Well Name: MONTREAL

Notice of Intent

Type of Action: Plug and Abandonment

CONDITIONS OF APPROVAL

Current Wellbore Schematic

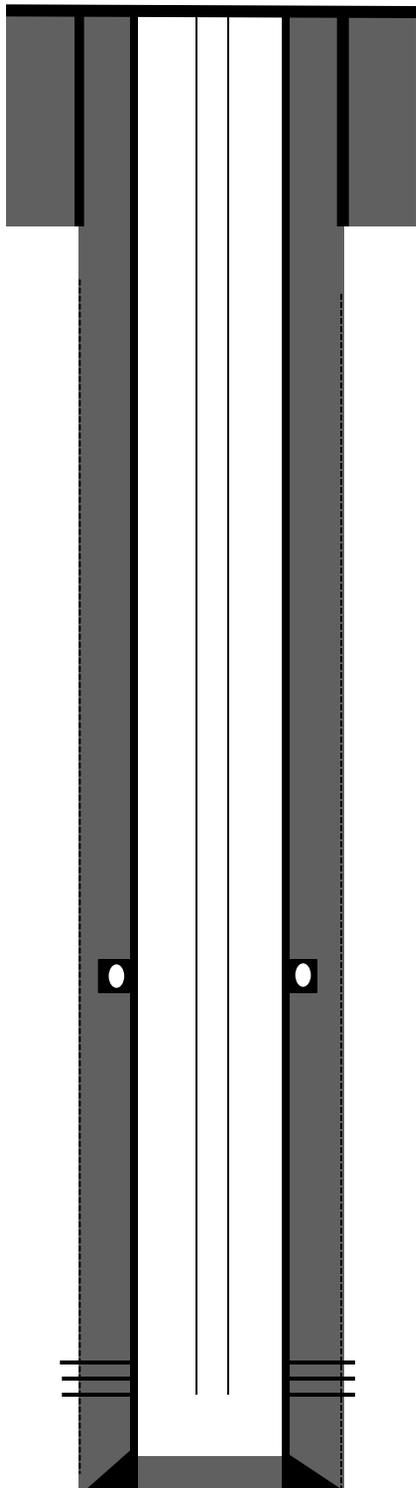
1. Plugging operations authorized are subject to the attached "General Requirements for Permanent Abandonment of Wells on Federal and Indian Lease."
2. The following modifications to your plugging program are to be made:
 - a. **Modify Plug 3. Make the TOC 1220' and the BOC 2115' to account for the BLM geologist's picks for the Upper Chacra at 1320' and the Cliff House at 2065' respectively.**
3. **Notification:** Farmington Office is to be notified at least 24 hours before the plugging operations commence at (505) 564 7750.

-Vertical wellbore, all formation depths are TVD from KB at the wellhead.
 -Modify Plug 3. Make the TOC 1220' and the BOC 2115' to account for the BLM geologist's picks for the Upper Chacra and the Cliff House respectively.
